**From:** Mayor Shawn Reilly  
**Sent:** Tuesday, September 09, 2014 10:51 AM  
**To:** Terry Thieme; Ald Eric Payne  
**Subject:** Crosswalks

To: Building & Grounds Committee  
From: Jennifer Andrews, Acting Community Development Director  
Date: September 9, 2014  
Re: Crosswalk at Niagara & Manhattan

## Manhattan at Niagara Crosswalk

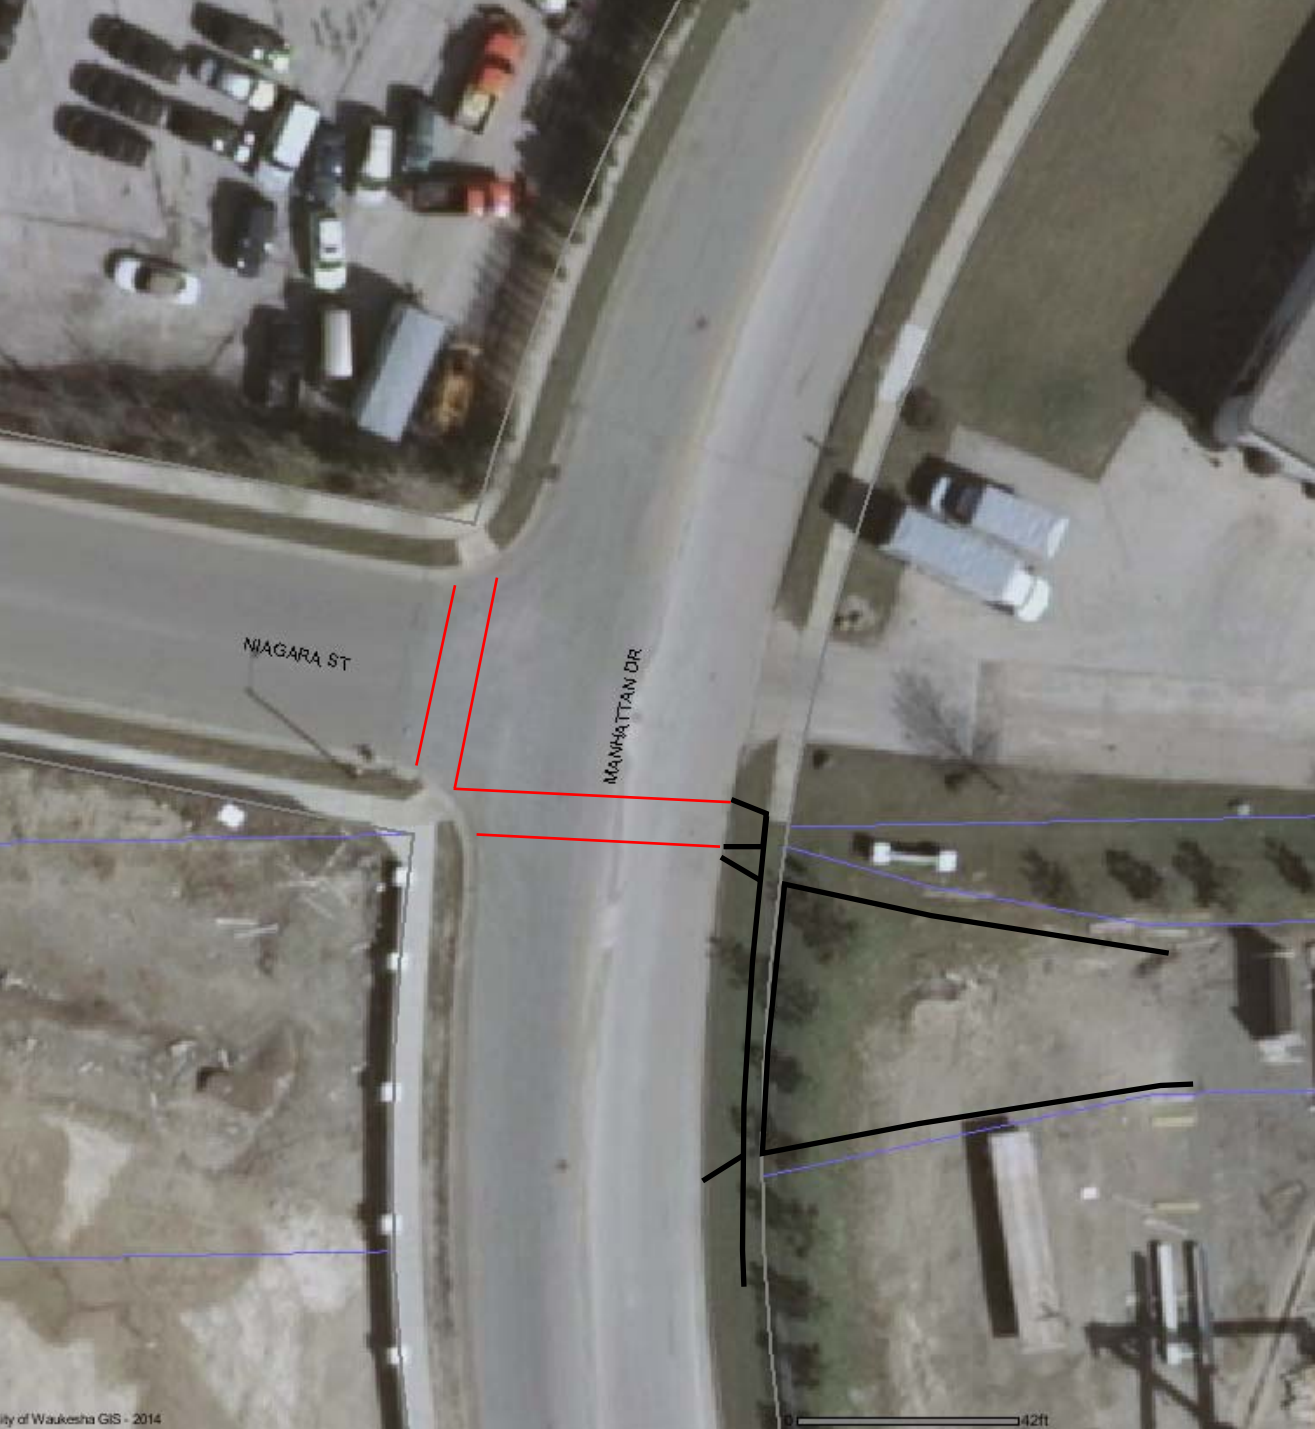
I was meeting with Jennifer this morning on proposed apartment buildings in downtown. While we were talking we also discussed the request for a mid block cross walk for Woodman's. I asked her to show me an photo of the location where the crosswalk would be located. After reviewing the photo, I commented that it appears very similar to the crosswalk that Alderman Patton has been requesting on East Ave and South Street. Maybe I am mistaken but I think the CC has repeatedly denied the crosswalk on East and South because it is midblock (maybe it truly is midblock and not lining up with South Street). The justification for not allowing the East Ave crosswalk is that it would be unsafe. I think a cross walk at Niagara and Manhattan also has the same type of issues.

Anyways, before we go through the process of working through the design and asking the developer to provide \$'s, we should determine whether this is where a crosswalk should be located. Maybe Public Works should discuss whether the two crosswalks are similar or whether the Niagara crosswalk would be different and safe.
